UNITED STATES PATENT AND TRADEMARK OFFICE

APPLICATION NO.	FILING DATE	FIRST NAMED INVENTOR	ATTORNEY DOCKET NO.	CONFIRMATION NO.
09/756,876	01/10/2001	Yasuo Himuro	Q62523	6217

Office Action Summary

Art Unit: 1733

With respect to the "auxiliary land part", a colored enlarged copy of figure 1 of Himuro is provided below:

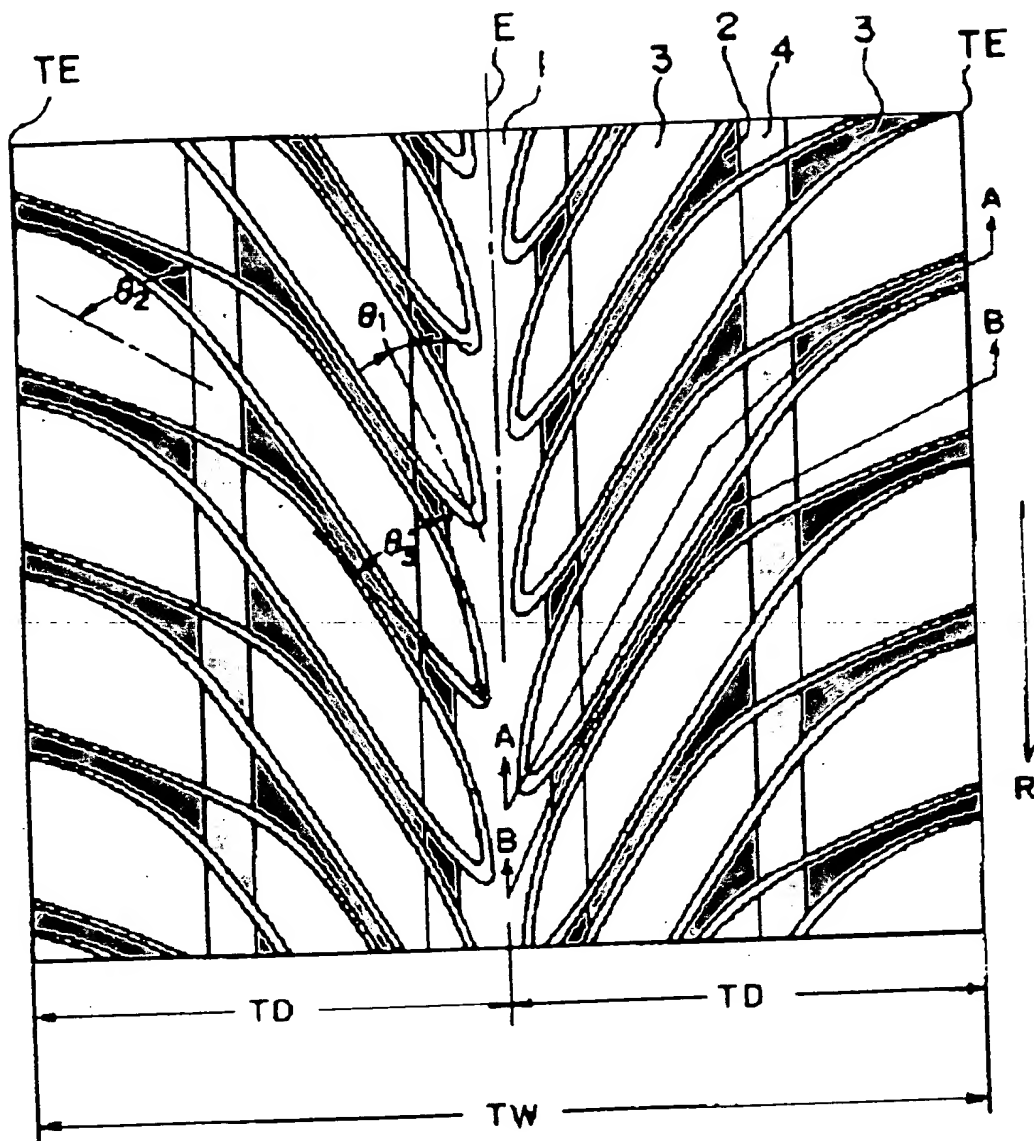
Applicant argues that Himuro fails to teach the "auxiliary land part". The examiner disagrees. The claimed auxiliary land part reads on the portion of the protrusion of the rib 1 having the gradually decreasing height.

The yellow, blue, orange and pink colors were added by the examiner. The ground contacting face of the rib 1, the blocks 2 and the blocks 3 is colored yellow. The slant grooves (the low height portions of blocks 2, 3) are colored blue. The first auxiliary land part is colored orange. The second auxiliary land part is colored pink.

Applicant argues that the seemingly steeply sloped portions of blocks 2, 3 define sides to circumferential grooves and have nothing to do with the gradually sloping auxiliary land part in claim 1. Applicant's argument is off point. The auxiliary land part in claim 1 reads on the portion of the protrusion of the rib 1 having the gradually decreasing height which is colored orange in the above colored applicant's figure 1.

Applicant argues that Himuro is completely silent regarding the angle of the sloped portions of blocks 2, 3. More properly, Himuro teaches gradually changing height to improve wet drainage performance and secure driving stability ability and partial wear proof performance and illustrates the change in height in figures 2 and 3.

Applicant argues that Hutson and Europe '709 fail to teach the auxiliary land part recited in claim 1. As noted above, Himuro teaches the auxiliary land part recited in claim 1. Hutson and Europe '709 suggest using the "approximately triangular" shape for the first land parts (blocks 3) of Himuro.
